## **NORTHERN BEACHES LOCAL PLANNING PANEL MEETING**

**WEDNESDAY 27 NOVEMBER 2019**

**Agenda for a Meeting of the Northern Beaches Local Planning Panel  
to be held on Wednesday 27 November 2019  
in the Council Chambers, Civic Centre, Dee Why  
Commencing at 1.00pm**

**Figure 2** - Carport roof identified on Second Floor Landscape Plan - LP04 Issue J (Source: mm+j architects)

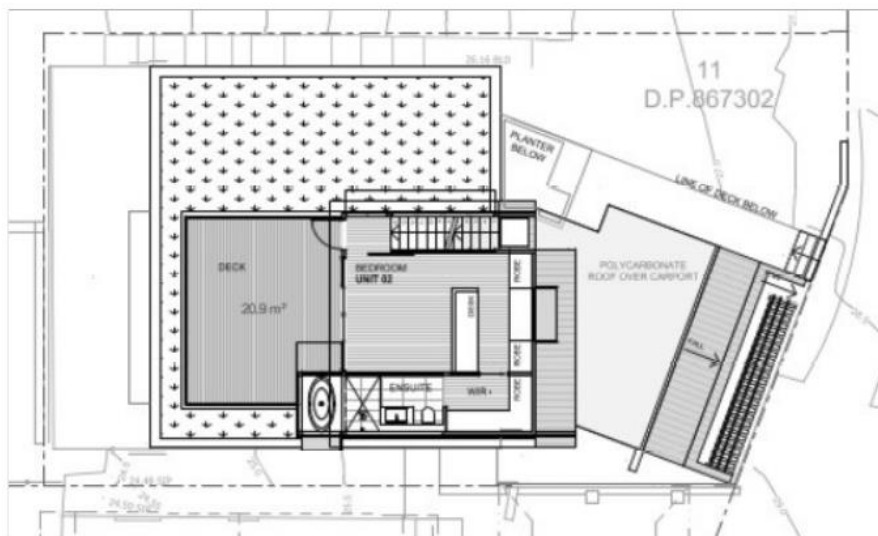
As the details of a carport structure within the front setback of the site are not completely represented, it cannot be concluded that this aspect of the proposal maintains and enhances the streetscape. This structure is not supported.

Figure 3 - Second Floor Plan - DA17 Issue L (Source: mm+j architects)

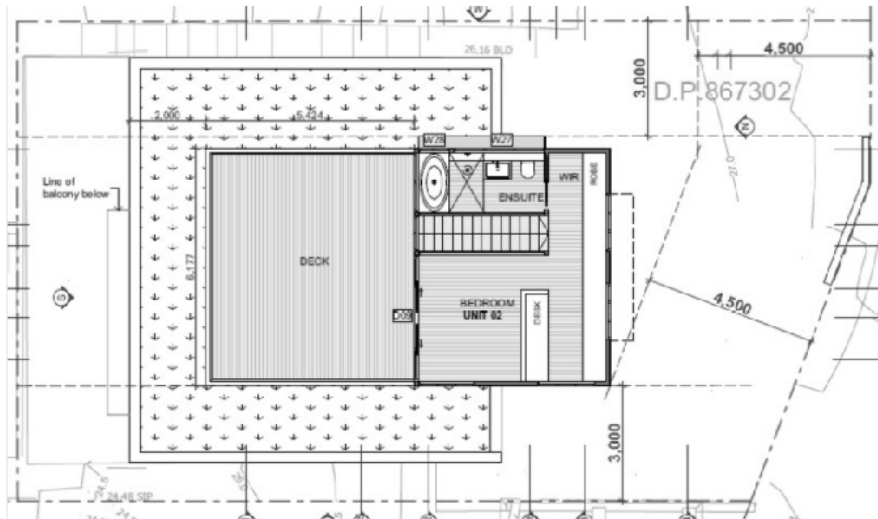
Some concerns were raised by the adjoining neighbour to the east in relation to privacy impacts from the proposed new second floor level bedroom and study area and also at first floor level W19 and W20 which adjoin a bedroom and bathroom respectively. The plans submitted with the application provide conflicting detail as identifiable in Figure 2 and 3 above in terms of the location and layout of the second floor level. While the windows referred adjoin spaces which are generally considered to low traffic, low impact areas, the windows are not considered likely to cause privacy impacts. This concern could be addressed more specifically with conditions around the sill heights and glazing of the windows, however as the applicant has failed to provide consistent plans, this issue is not considered suitable to condition and forms a reason for refusal.

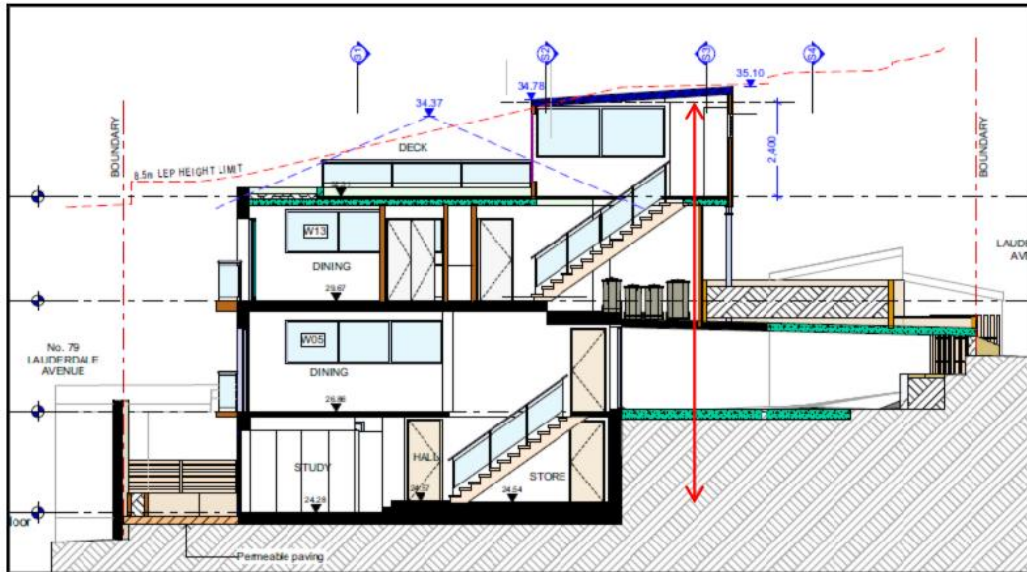
The proposed maximum height of 10.2m represents a variation of 1.7m from the numerical height standard in the LEP. Such height has been calculated from the existing ground level of RL24.54 to the height of RL34.78.
